ND-10-0964

Southern Nuclear Operating Company
Vogtle Electric Generating Plant Units 3 and 4
Site Safety Analysis Report License Amendment Request
Revise Backfill Geometry

**Vogtle Electric Generating Plant Units 3 and 4
Site Safety Analysis Report License Amendment Request
Revised Backfill Geometry**

SSAR Markup

Figure 2.5.2-66 Low Strain Shear Wave Velocity Profile Cases (LB, BE, UB) - Study for Material Over Excavation Slopes

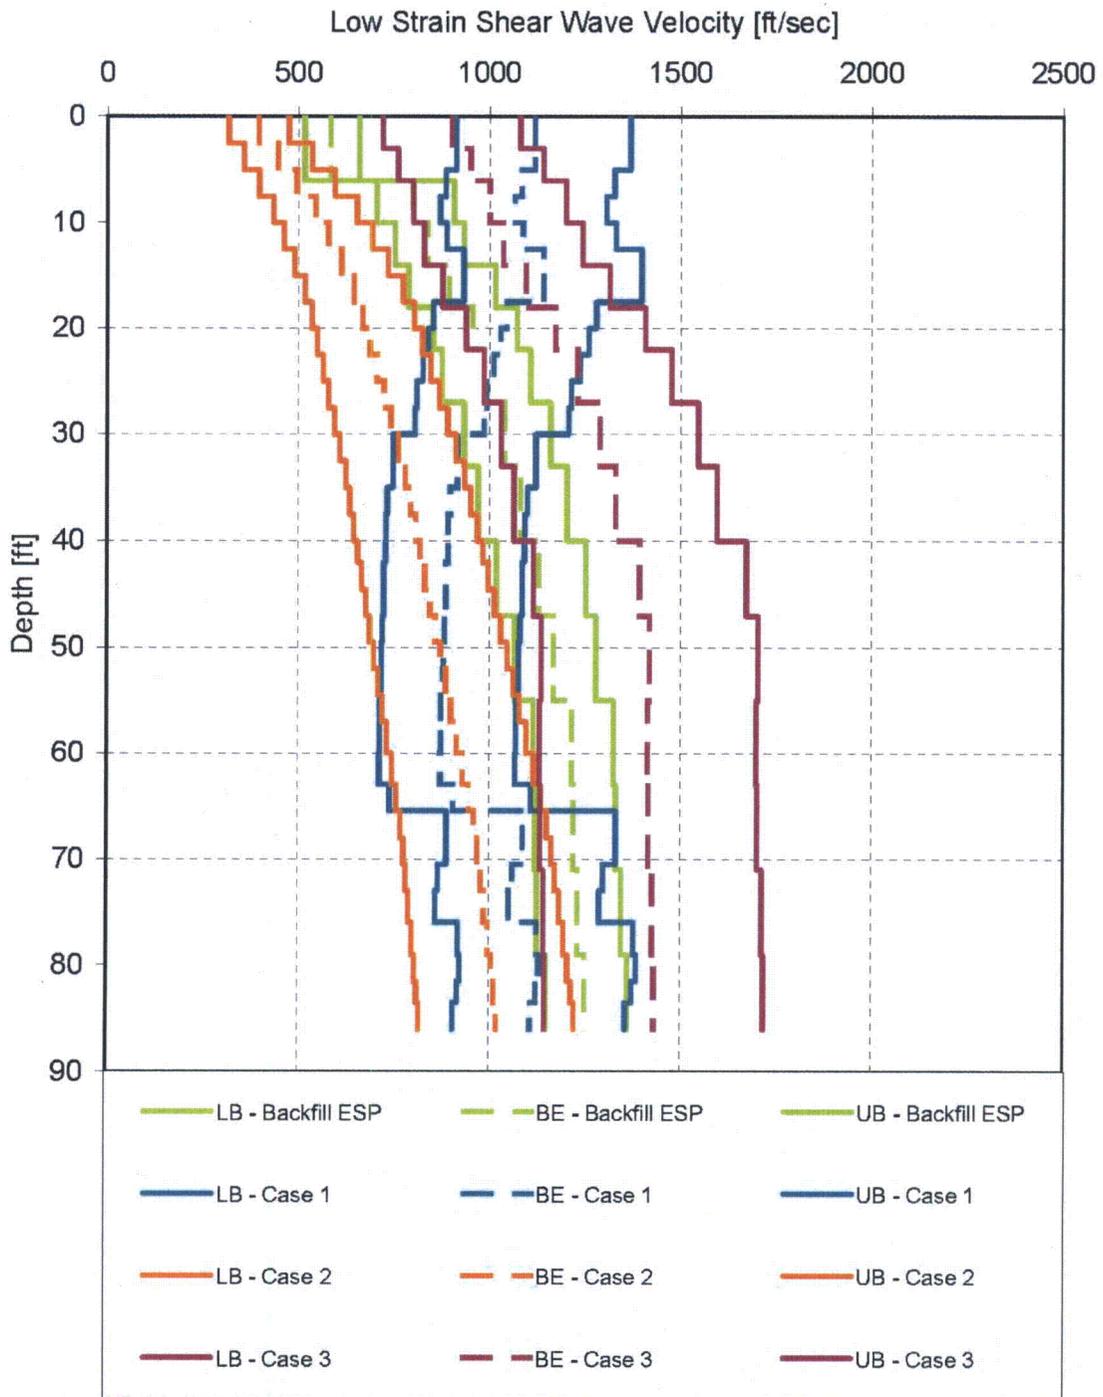
Figure 2.5.2-66 is a plot of the Lower Bound (LB), Best Estimate (BE), and Upper Bound (UB) low strain profiles for the ESP Category 1 and 2 backfill, Case 1, Case 2, and Case 3. This figure demonstrates the breadth of the variation of the shear wave velocity profiles considered for backfill material over the slopes of the excavation in order to assess the significance of material placed over the slopes on the results and conclusions provided in 2.5.2.9.2. Figure 2.5.2-67 is a comparison of the strain compatible BE shear wave velocity profiles for ESP Category 1 and 2 backfill used in the sensitivity analysis of 2.5.2.9.2 (identified as Base Case in the figure) along with Cases 1, 2, and 3 used in the 2D SASSI SSI bathtub models.

Figure 2.5.2-68 Comparison of SASSI 2D Bathtub Model Site Response: Amplification at 0 ft (GMRS horizon)

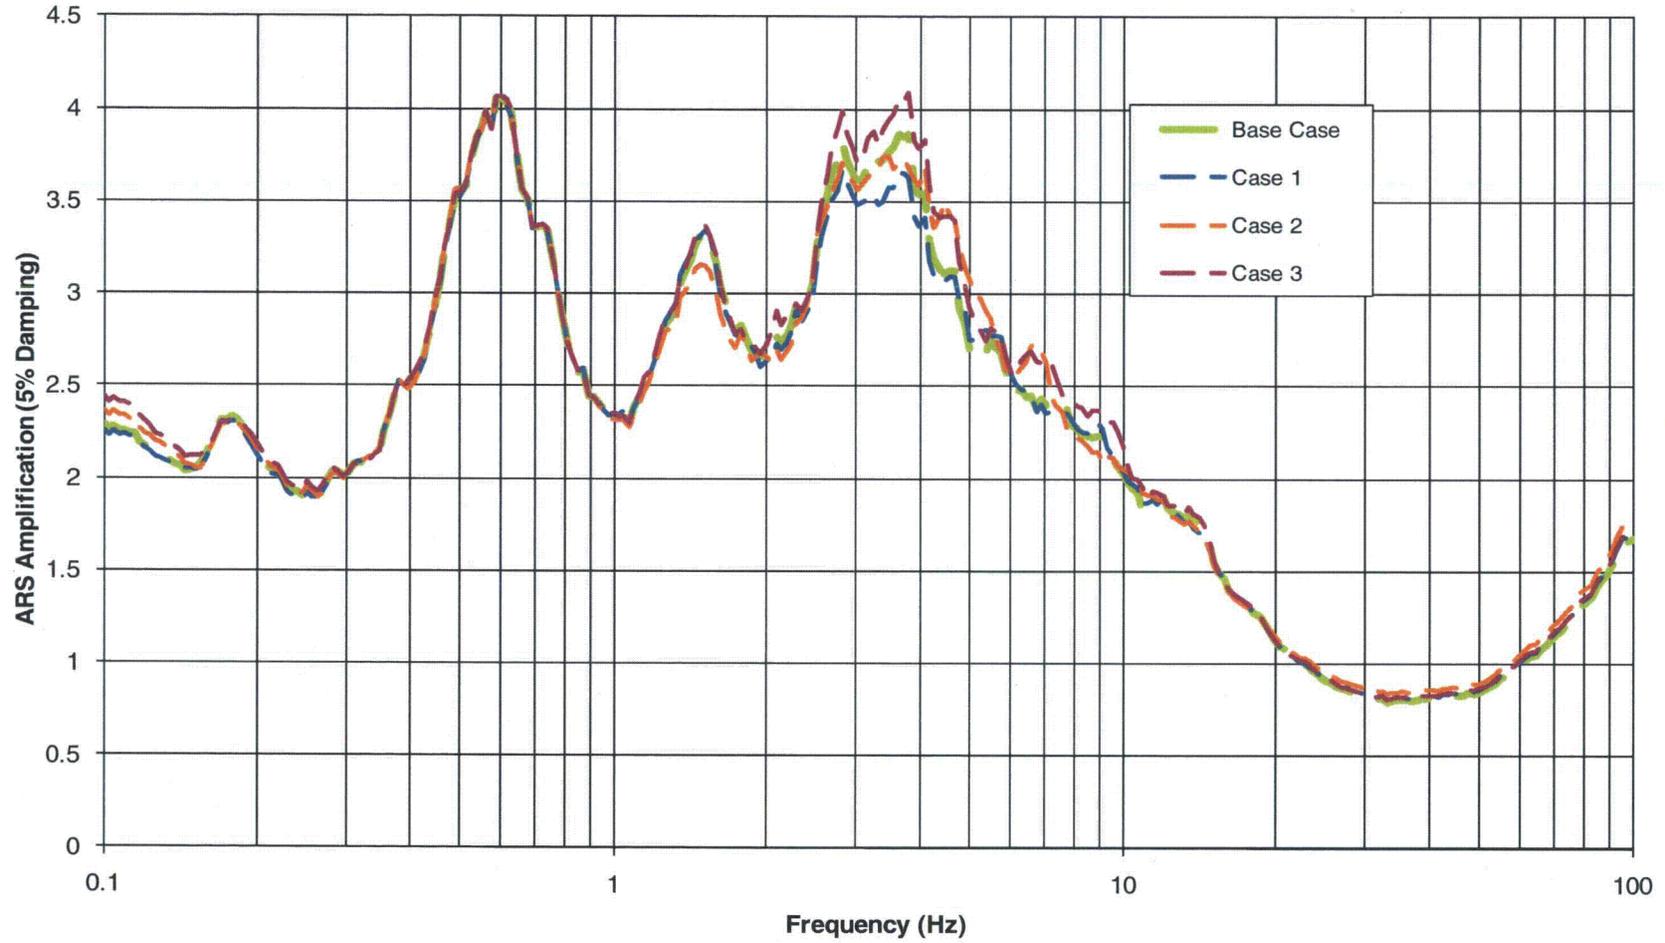
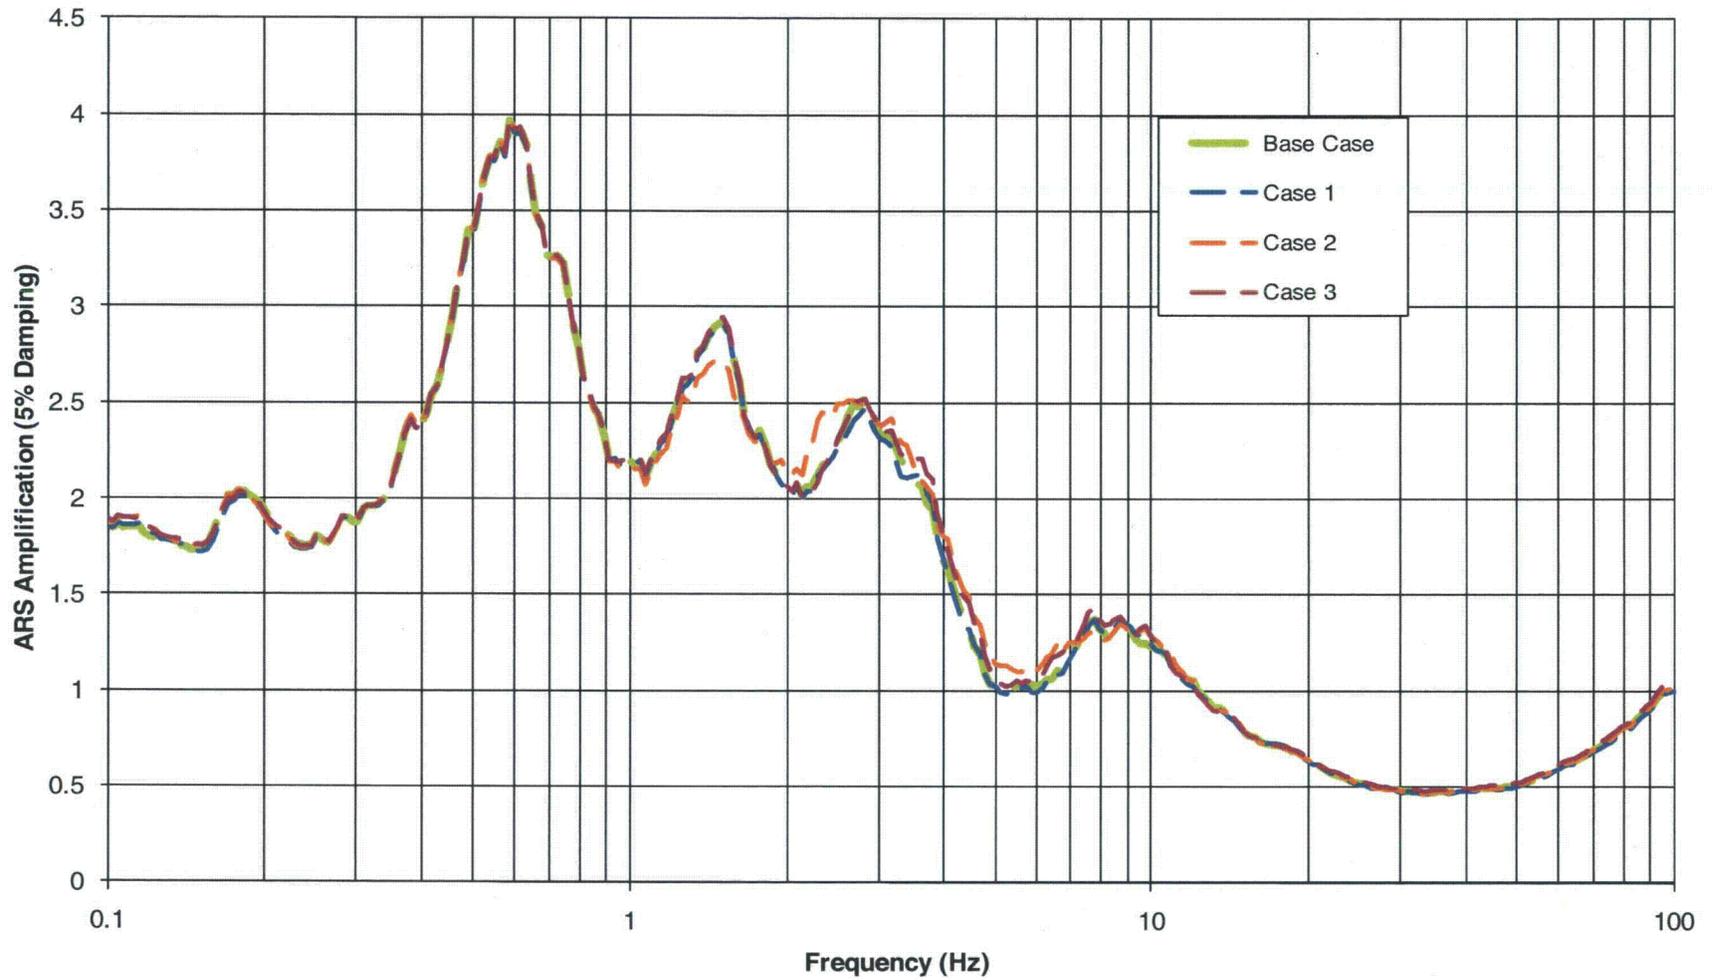
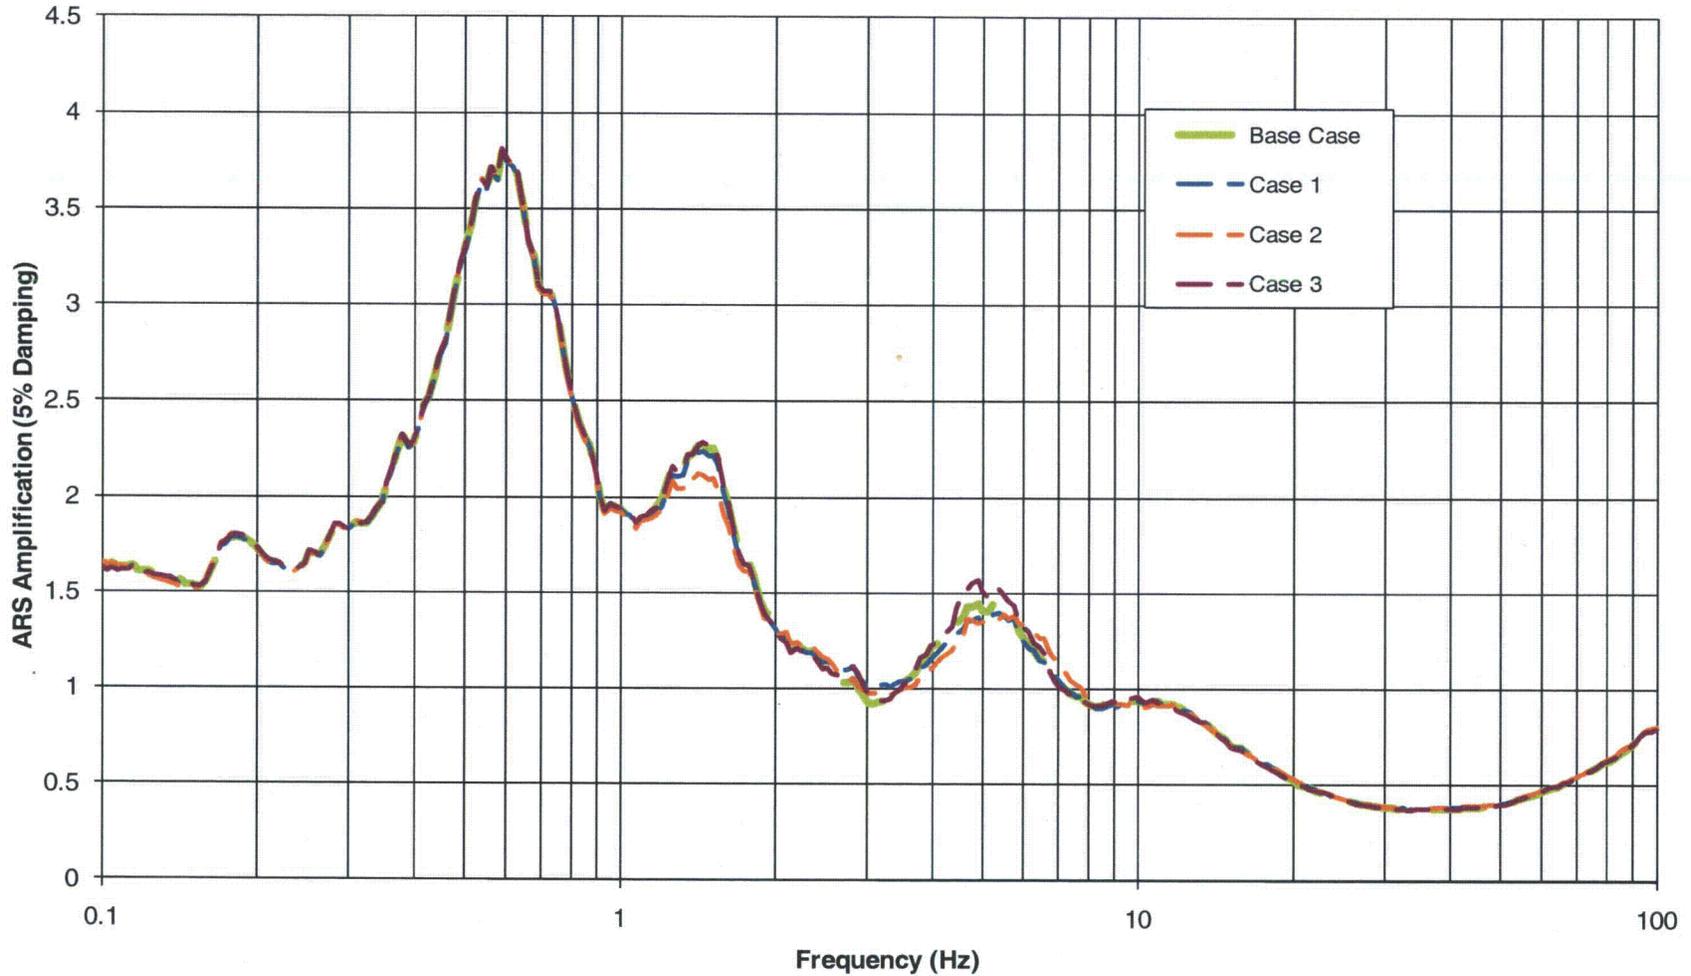
Part I of 2.5.2.9.2 provides the sensitivity study for seismic site response. The same 2D SASSI bathtub model shown in Figure 2.5.2-54 was used, except the material over the slopes was changed. Three cases described above were considered, the results of Cases 1, 2, and 3 are compared to the 2D SASSI bathtub results of 2.5.2.9.2 identified as "SASSI-BF-IS." The results in the form of spectral amplification factors versus frequency are shown in Figures 2.5.2-68, 2.5.2-69, and 2.5.2-70 at three horizons: at a depth of 0 ft (GMRS Horizon), at 40 ft depth (FIRS horizon), and at 86 ft depth (top of Blue Bluff Marl) respectively. As shown in these figures the differences are very small confirming that backfill with shear wave velocities lower and higher than Category 1 and 2 backfill can be placed over the slopes without invalidating the results and conclusions provided in 2.5.2.9.2.
